PURPOSE OF RELOCATING 1ST FLOOR RESTROOM

EXHIBIT A-1 CURRENT 1ST FLOOR PLAN

EXHIBIT A-2
REVISED 1st FLOOR PLAN

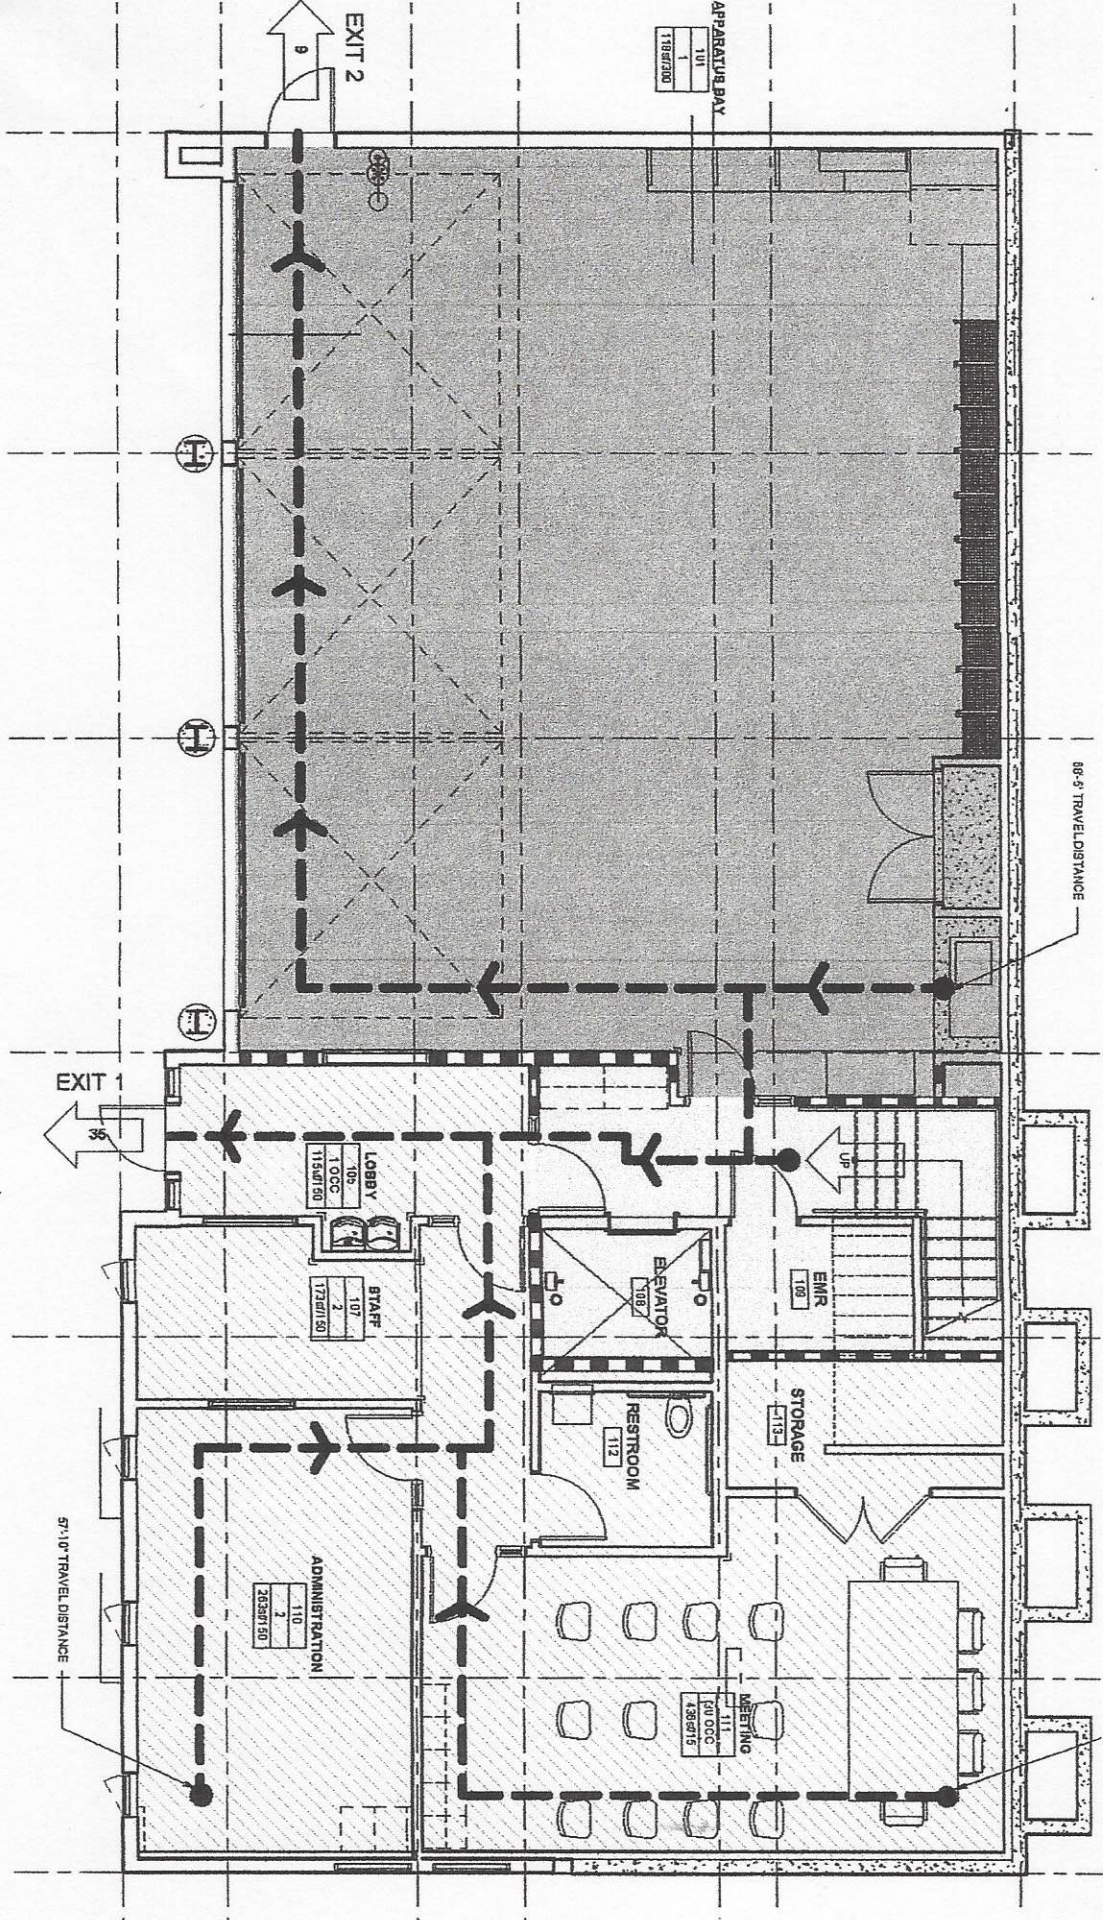
Exhibit A-1 shows the space allocation of the 1st floor planned for fire use. As shown, the 1st floor will be used for a large meeting room that can accommodate 17 people, a storage area and a sizeable area for administrative staff. None of this space is required by code and the 17 seat conference room actually exceeds the occupancy capacity allowed by code. **Moreover, the restroom is located in the center of the floor creating layout inefficiencies in the overall floor plan.**

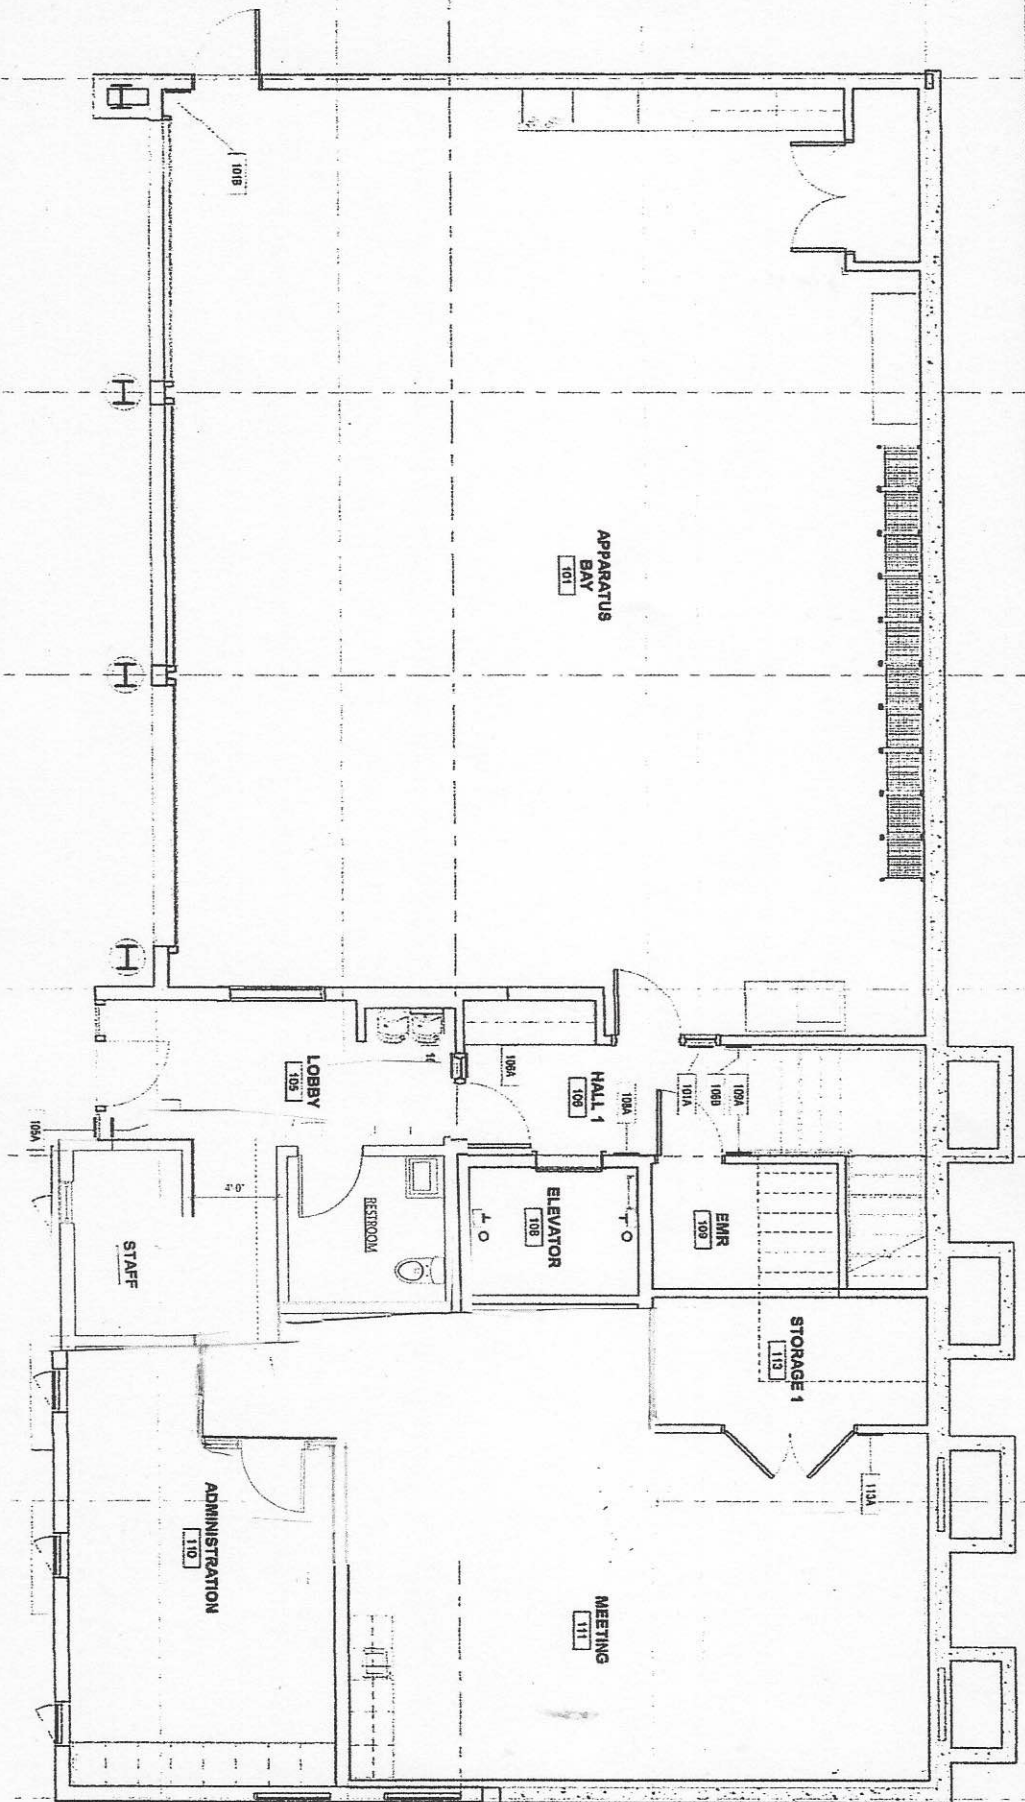
Exhibit A-2 indicates that by relocating the restroom from the south to the west side of the elevator the office layout becomes much more efficient. And, since discussions are underway about possibly providing this downstairs area to the police a relocation of the restroom should be undertaken soon in order to maximize the layout efficiencies for possible police use.

Recommendation – The efficiencies of the proposed relocation of the restroom should more than compensate for any cost increase. And, should this space be converted to police use it will leave firefighters with the use of the 1st floor restroom and conference room.

WATT FLOOR 1

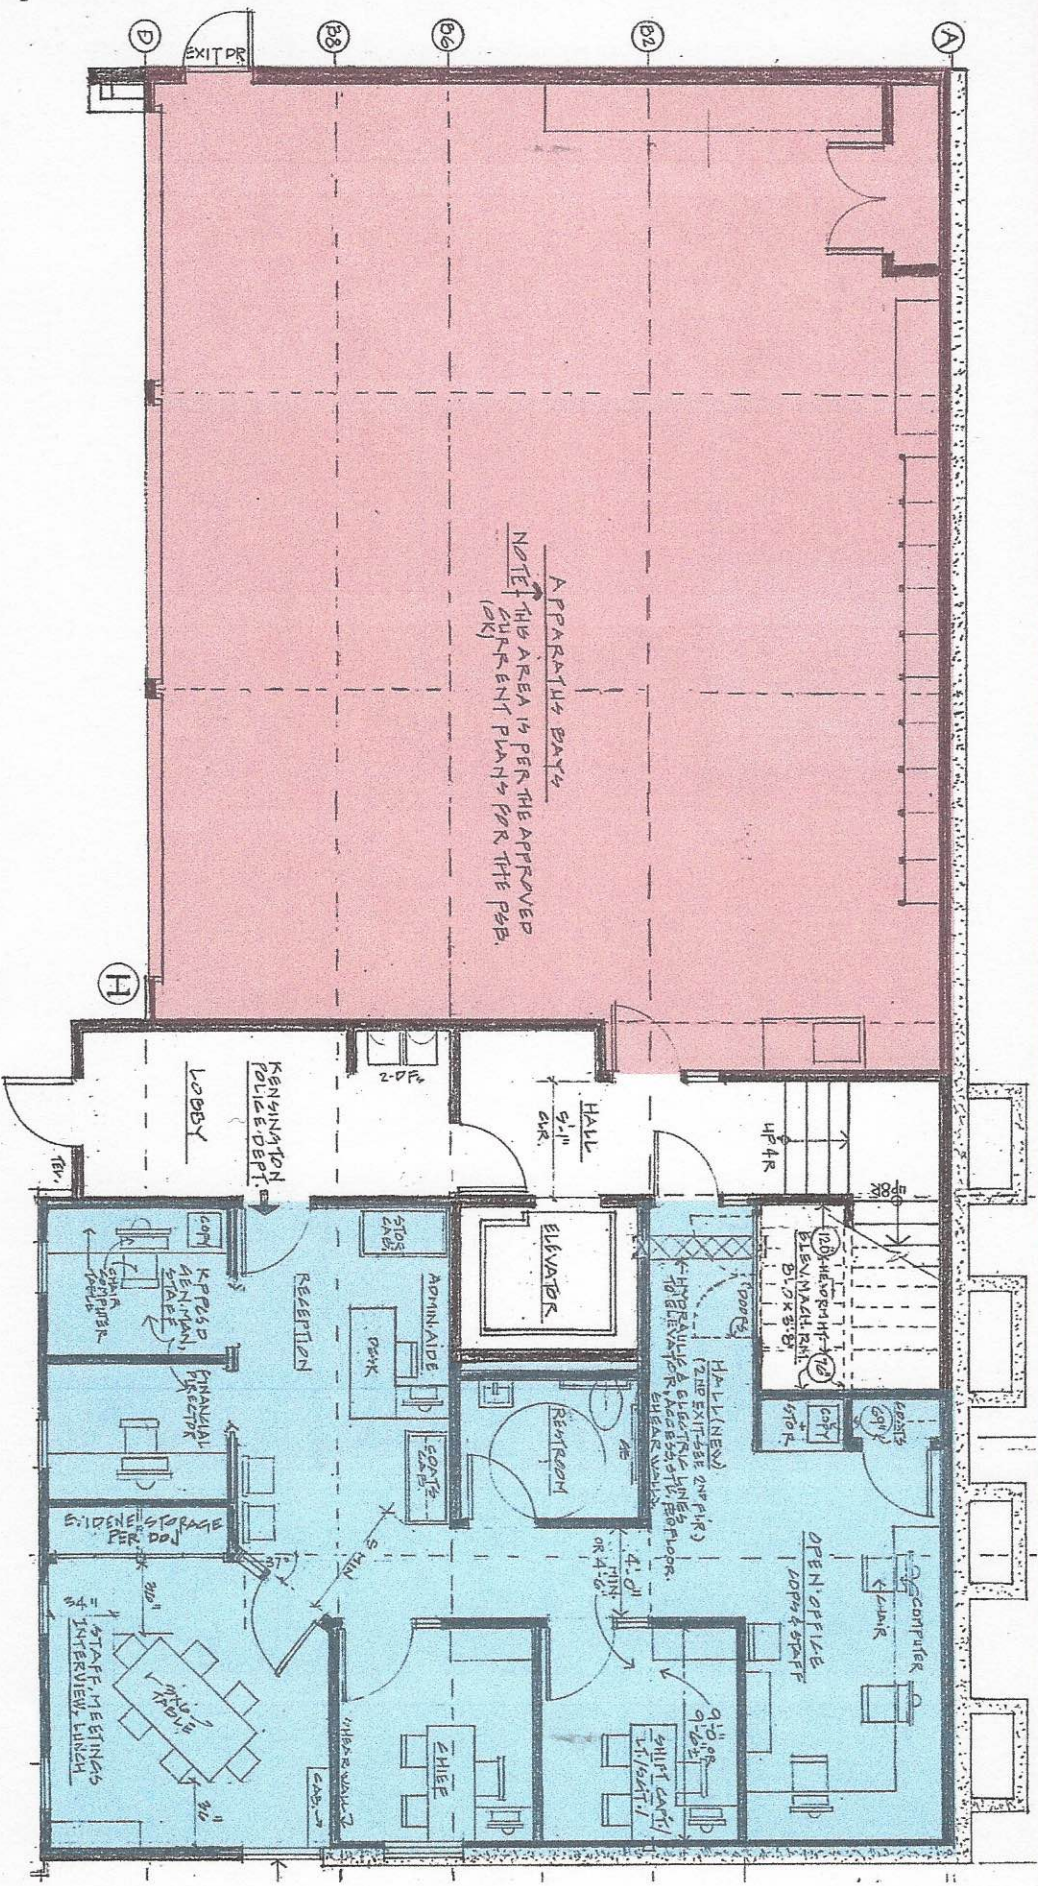
Watt Plan (attached) – This plan relocated the restroom in front of the elevator with the restroom door facing the entry hall, thereby making it accessible from the hallway (visitors) the apparatus bay (firefighters) and the police offices. The negative to this plan is the need for an revision to the approved floor plan which will require architectural work, plan check time and a change order with the contractor.
